ADDENDUM No. 3

**Airfield Lighting Vault Expansion
AIP # 3-33-0011-TBD-2025
Bid # FY25-804-38**

at the Manchester – Boston Regional Airport

Date: March 31, 2025

CCR SWITCHGEAR RS-2 PLAN AND ELEVATION

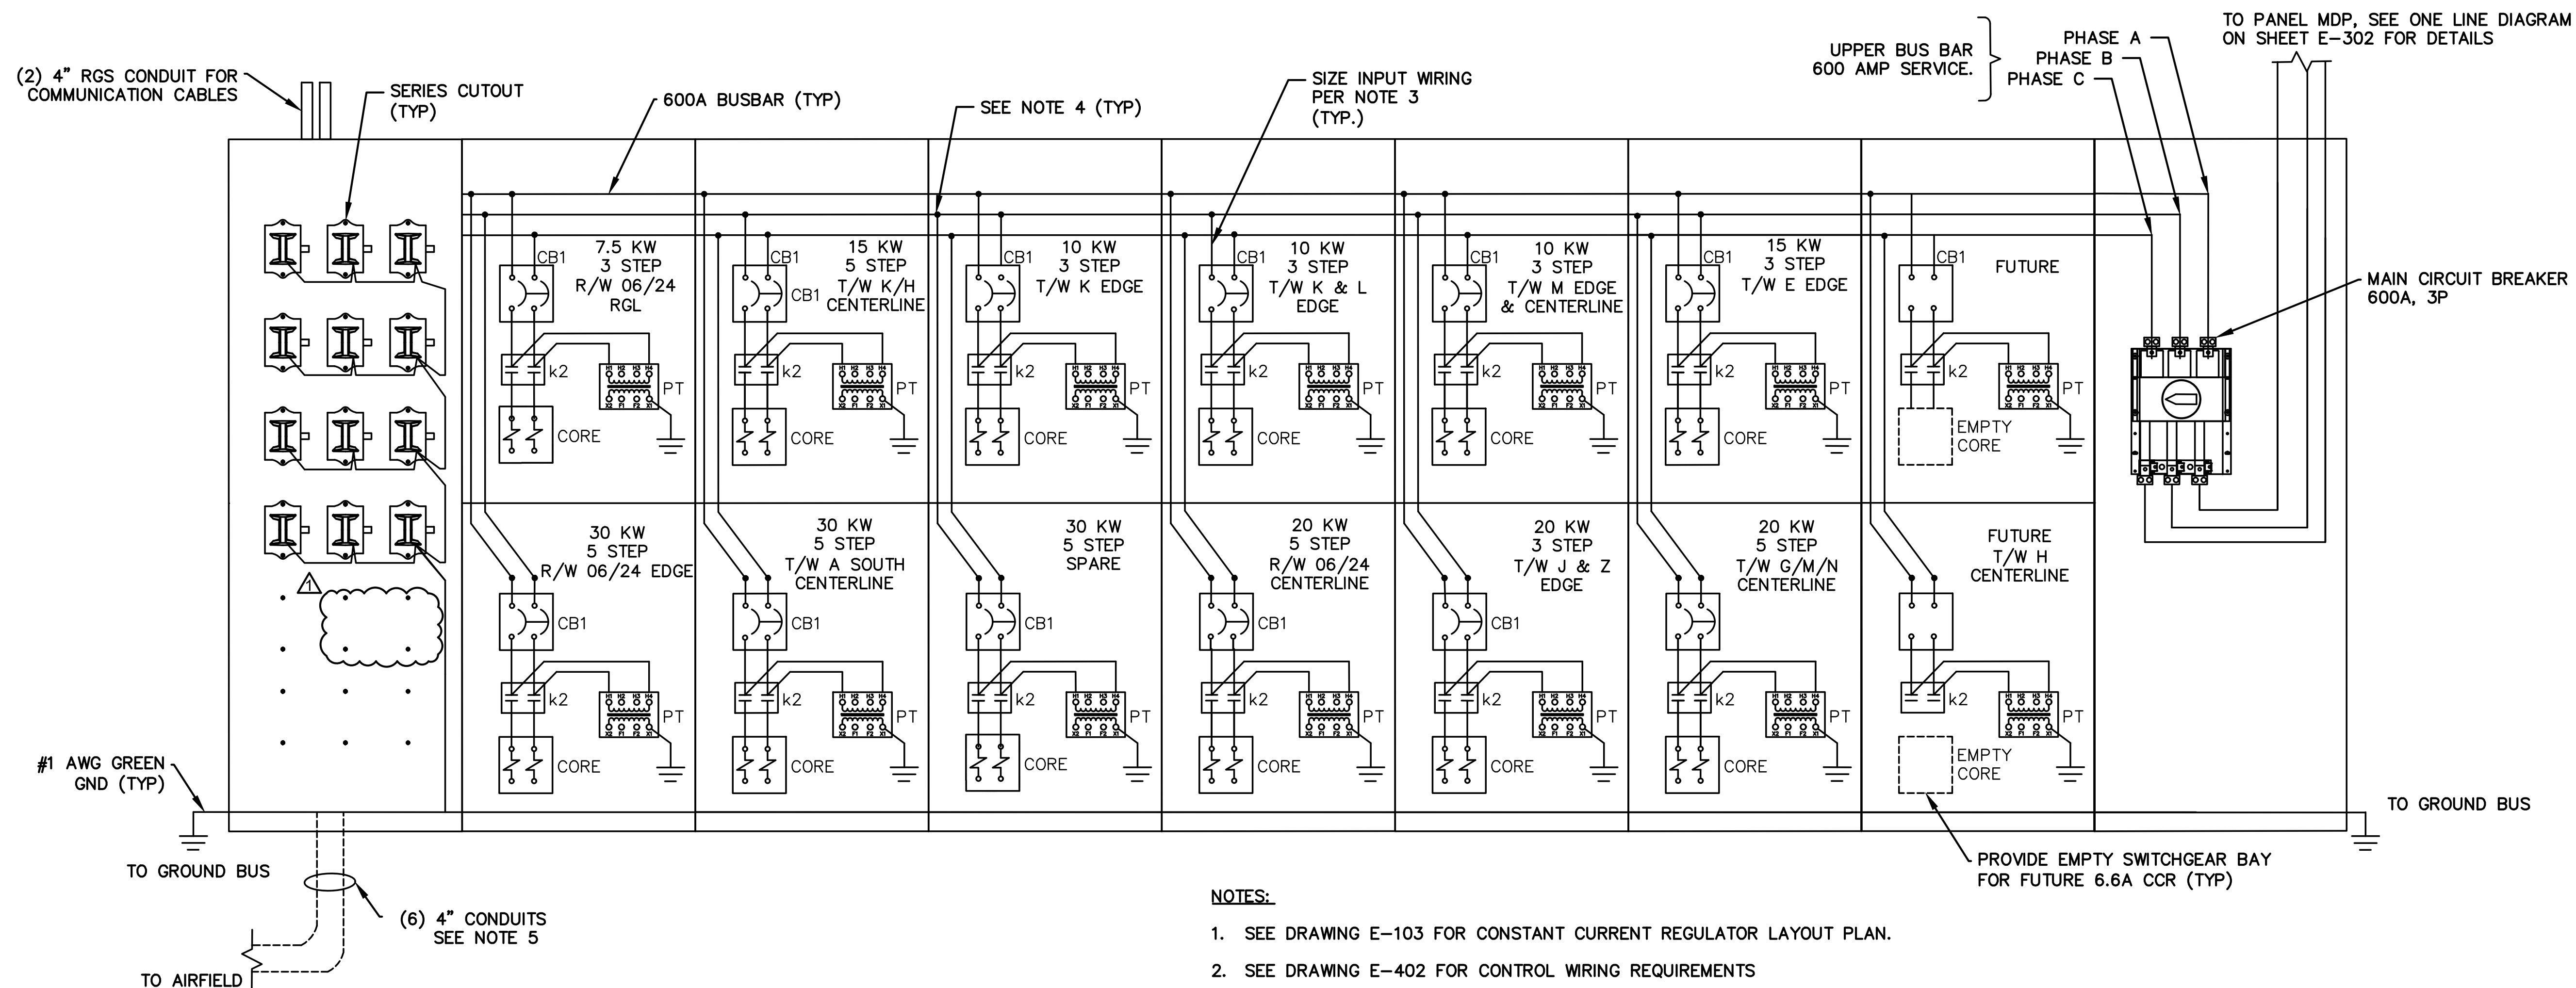
Q1: Please confirm the required number of S1 cutout in switchgear RS-2. The drawing shows 13 units, but as there are 3 slots for future CCRs, shouldn't there be 16?

A1: Provide an S-1 cutout for all new CCR bays that will be outfitted with a power core. Therefore provide (12) S-1 cutouts for RS-1 and provide (13) S-1 cutouts for RS-2.

OVERALL ELECTRICAL VAULT
FINAL ONE-LINE DIAGRAM

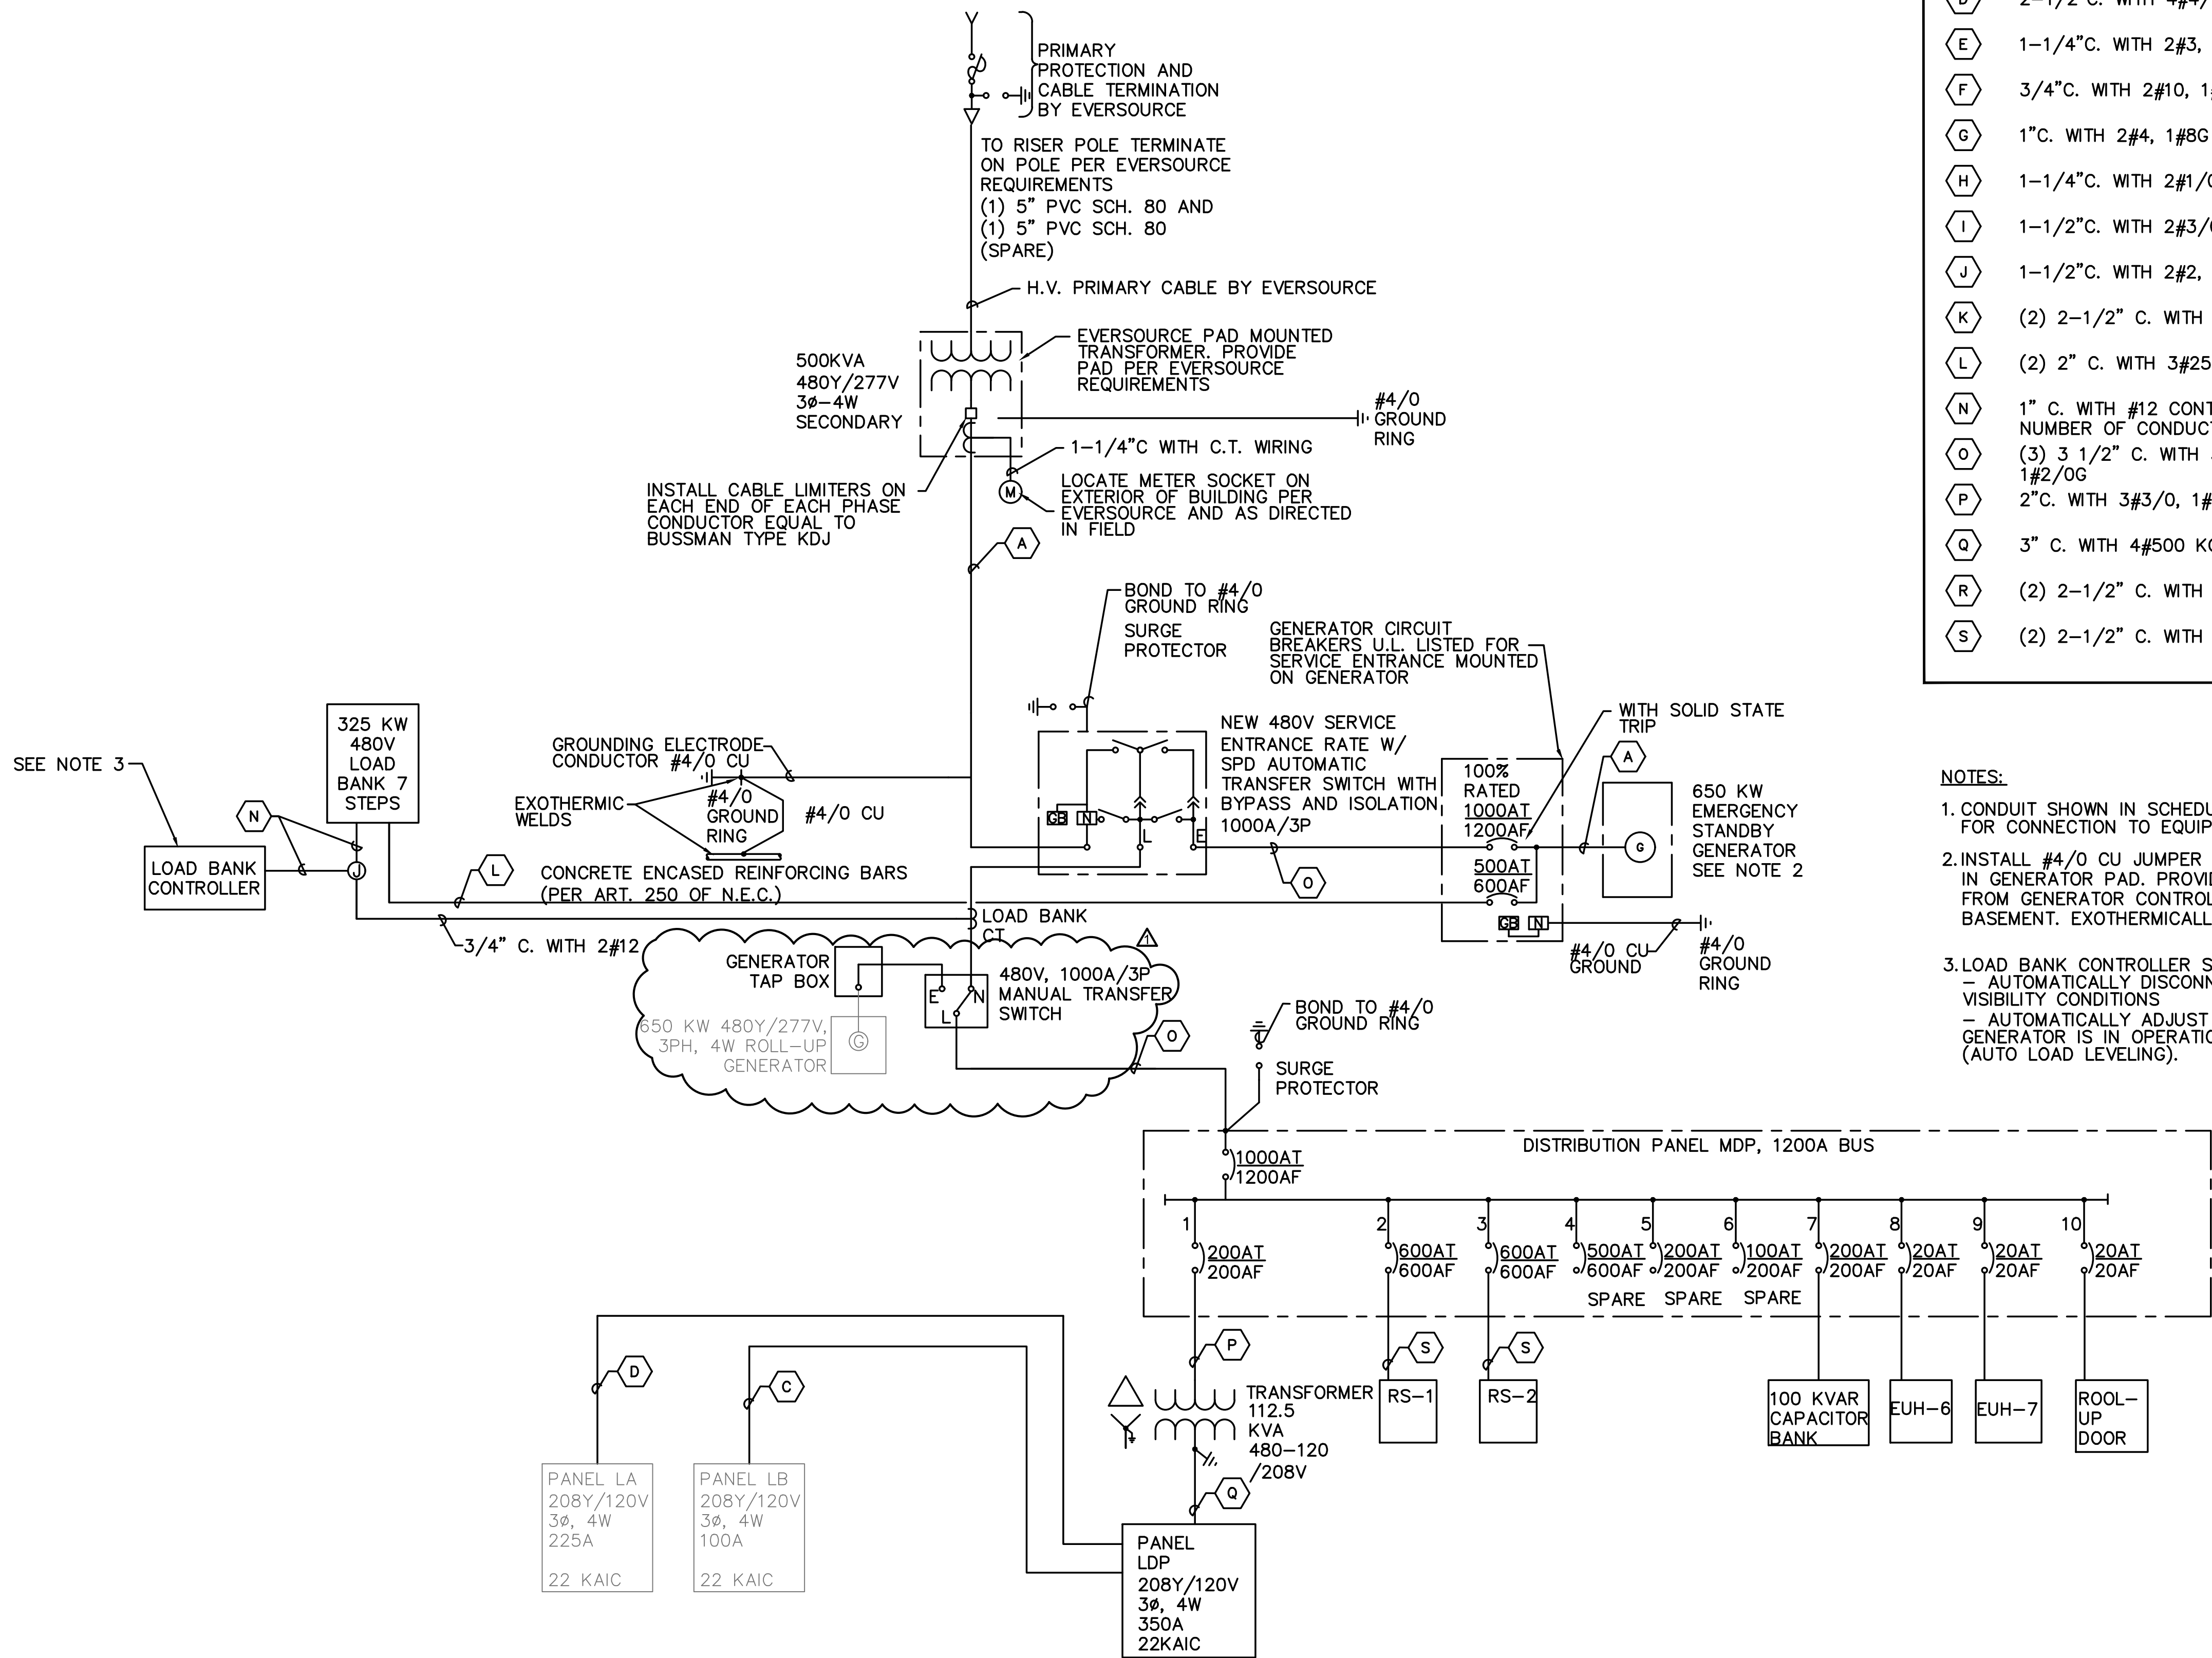
Q9: On the one-line diagram it shows 2-5" conduits from the pole to the new pad. On sheet E-505 there's a detail that shows 4- 5" conduits terminating at the pad. Please confirm the number of conduits needed.

Q10: Do we need to provide the 4 4" for future secondaries as well? Please advise.

A9: The one-line diagram takes precedence - 2-5" conduits are needed.

A10: The one-line diagram takes precedent - 4-3.5" conduits are needed.
